Revisions:
7/2005 REVISIONS PER COMMENTS FROM PERMITTING PROCESS

WOODLANDS AT LAUREL HILL
Acton & Westford, Mass.

Site Plan

C-1

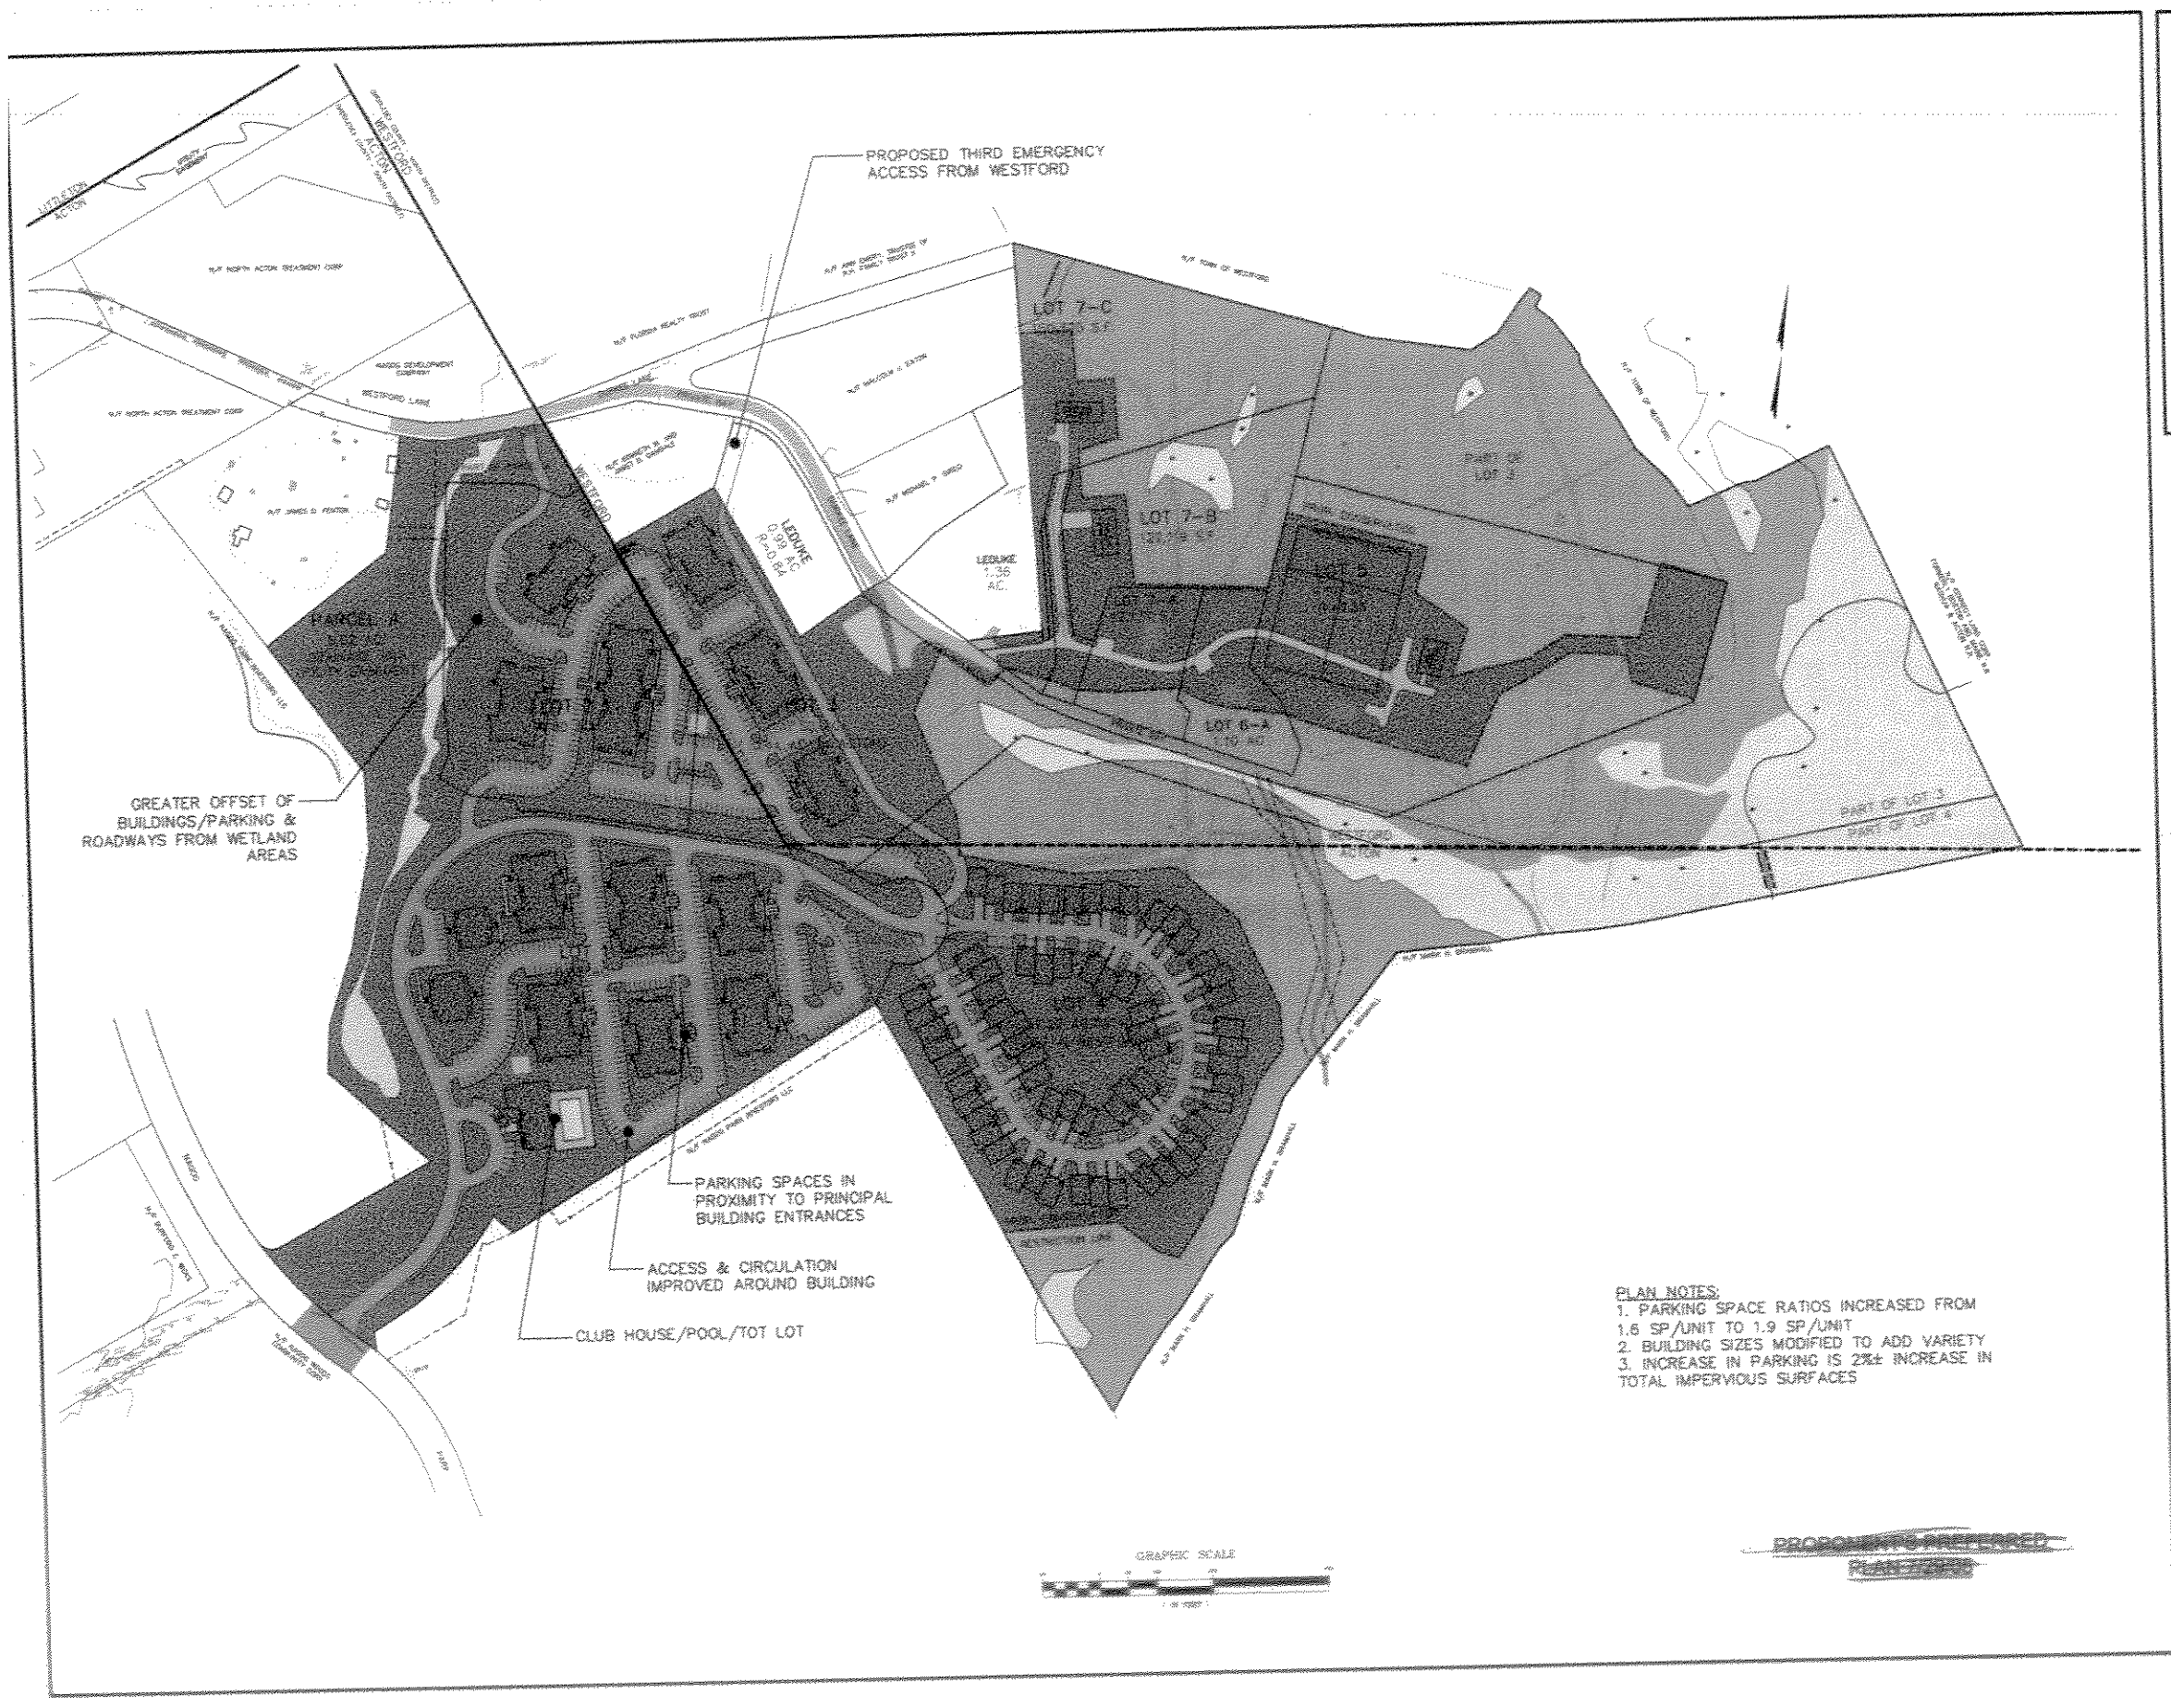
PLAN NOTES:
1. PARKING SPACE RATIOS INCREASED FROM 1.6 SP/UNIT TO 1.9 SP/UNIT
2. BUILDING SIZES MODIFIED TO ADD VARIETY
3. INCREASE IN PARKING IS 2%± INCREASE IN TOTAL IMPERVIOUS SURFACES

C-1

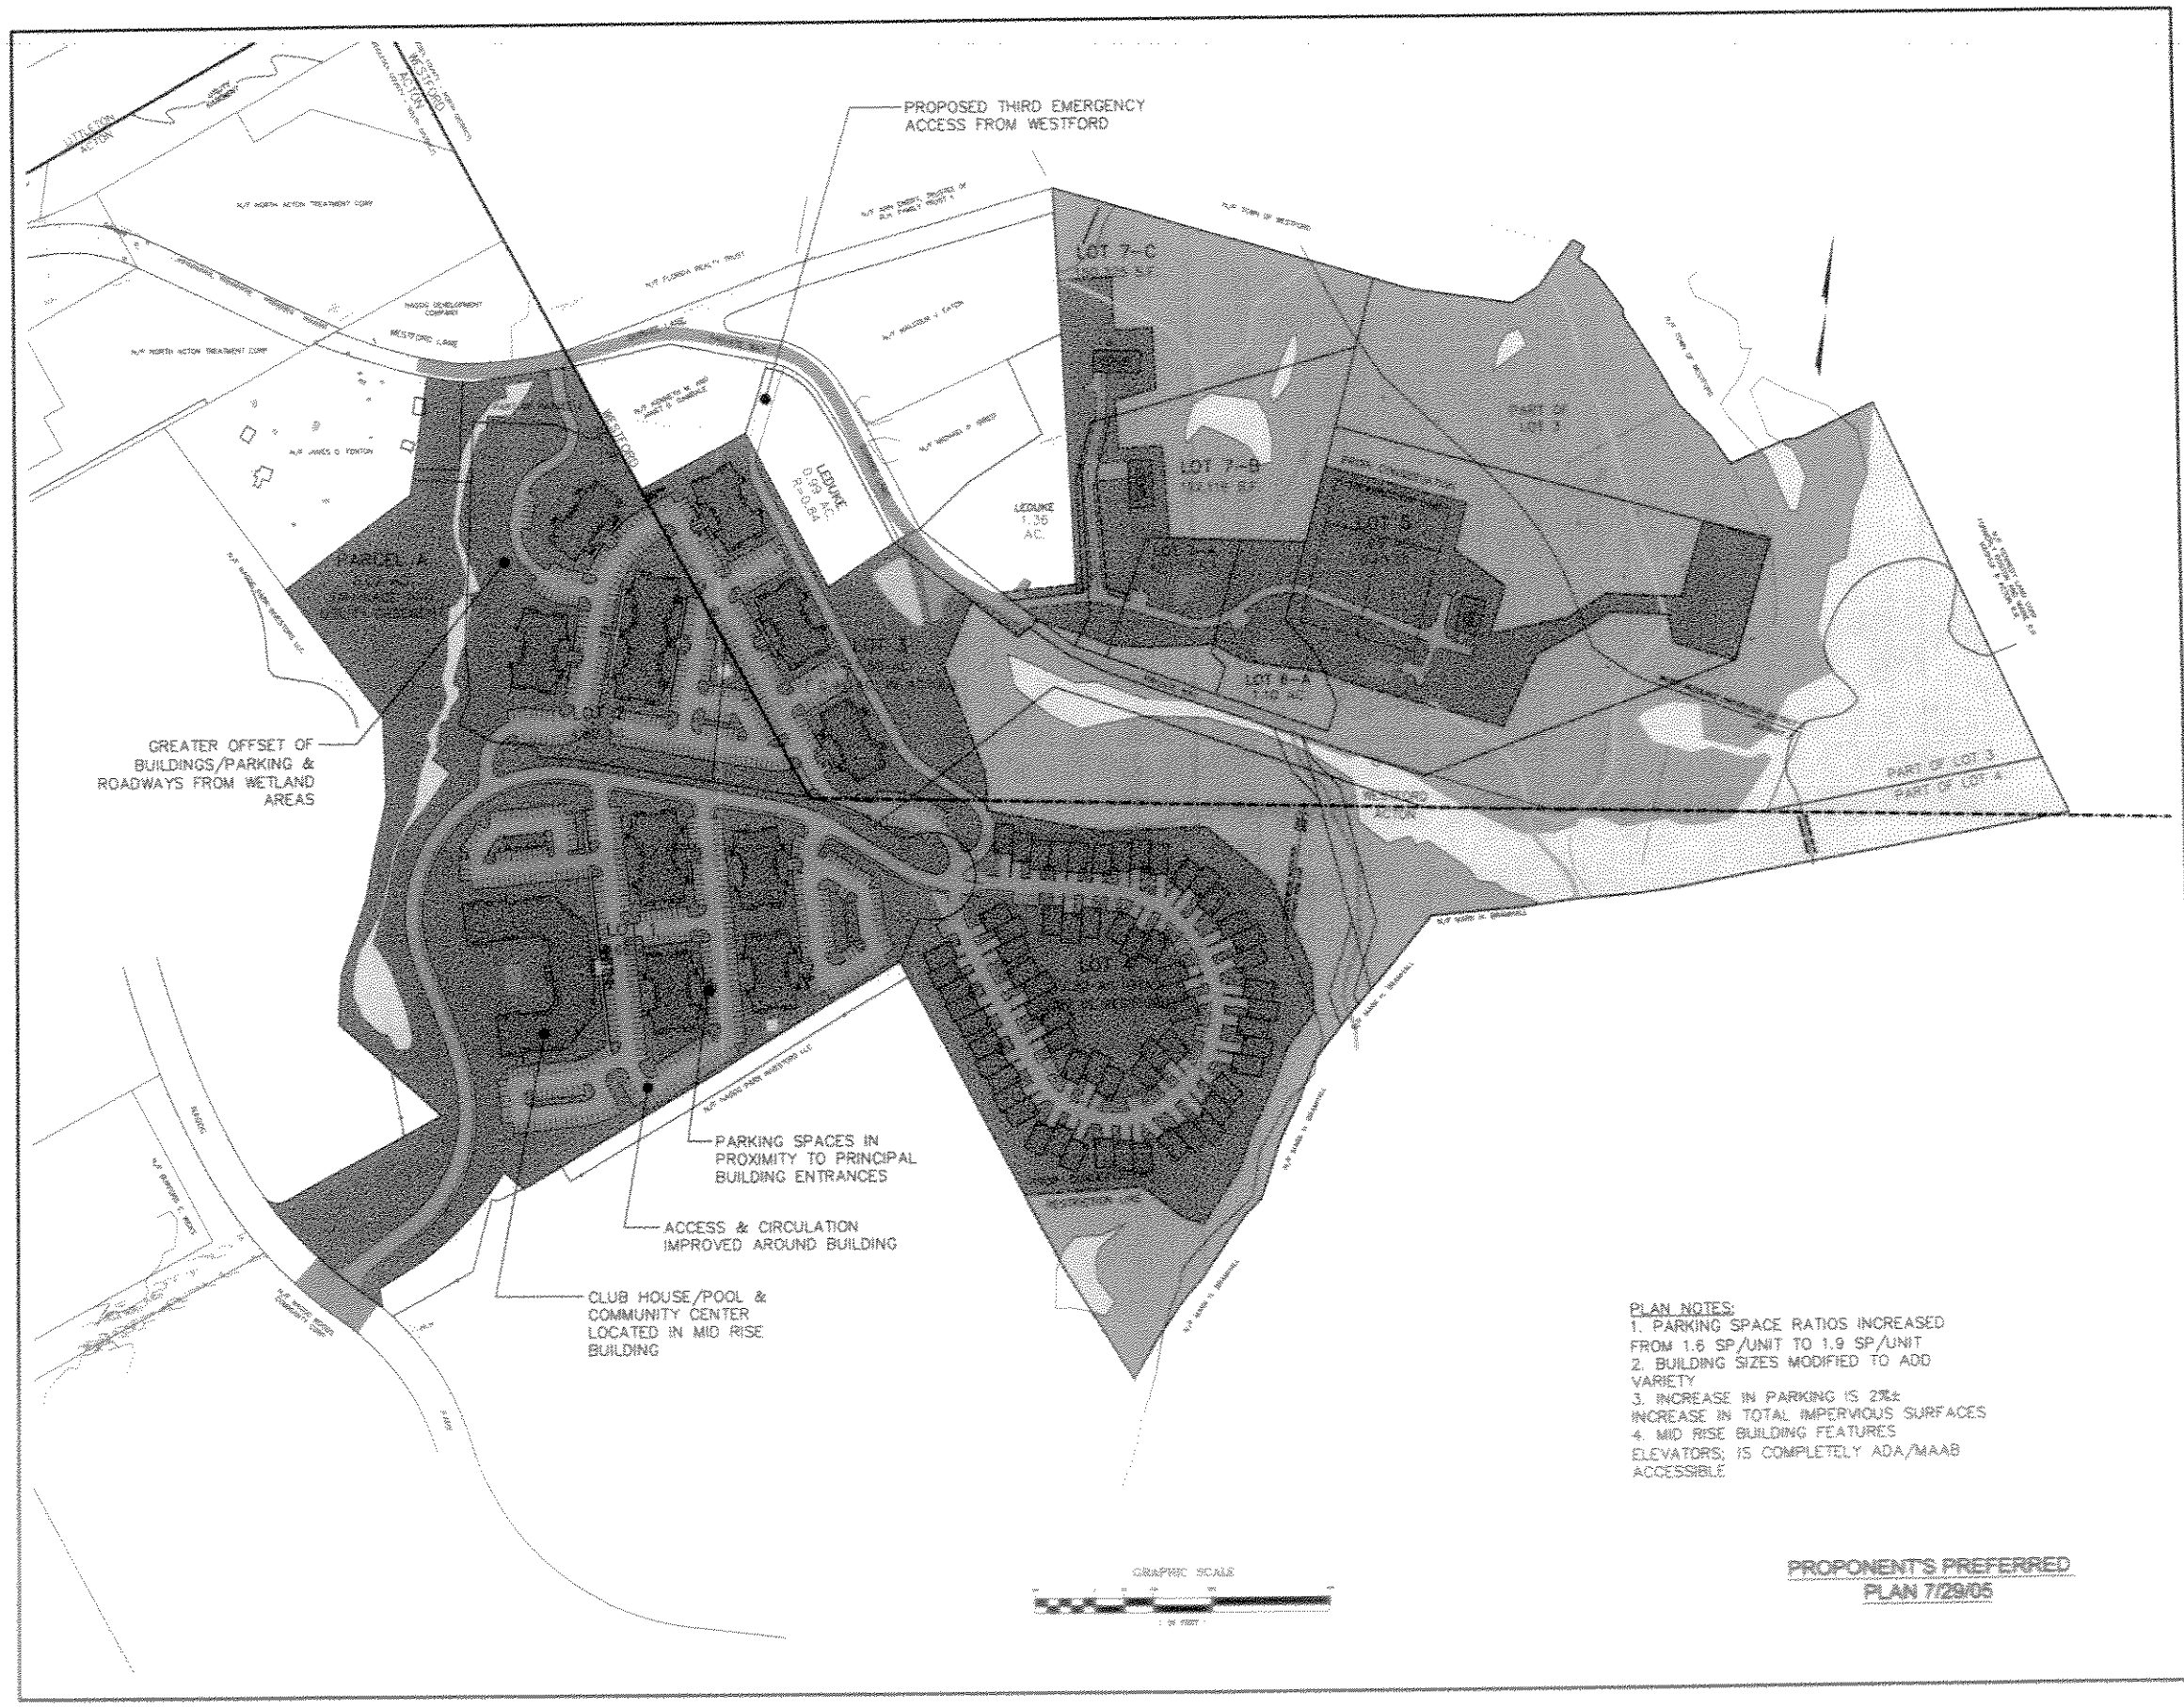
PLAN NOTES:
1. PARKING SPACE RATIOS INCREASED FROM 1.6 SP/UNIT TO 1.9 SP/UNIT
2. BUILDING SIZES MODIFIED TO ADD VARIETY
3. INCREASE IN PARKING IS 2%± INCREASE IN TOTAL IMPERVIOUS SURFACES
4. MID RISE BUILDING FEATURES ELEVATORS; IS COMPLETELY ADA/MAAB ACCESSIBLE

Revisions:
7/29/05 REVISIONS PER COMMENTS FROM PERMITTING PROCESS
